# Service Information

**TITLE** : New manual resettable microswitch on steam boiler pressure switch

**MODEL** : FreshMilk

**NUMBER** : SI 230322

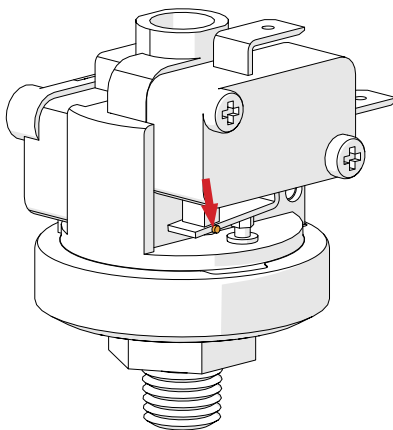
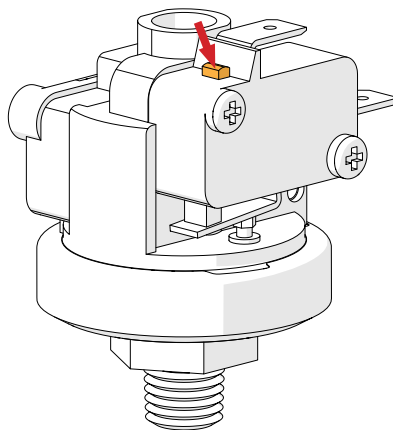
Due to problems with the availability of the microswitch on the steam boiler pressure switch, the manually resettable microswitch was changed.

The manual resettable switch of the new micro switch has a different position, see the below picture for the new position.

press the button, at the bottom,  
down to reset

press the button, at the top, to  
reset

The first machine with the new micro switch has serial number **020002379063**.

The microswitch is **integrated** in the steam boiler pressure switch and the complete steam boiler therefore it **cannot** be ordered separately.
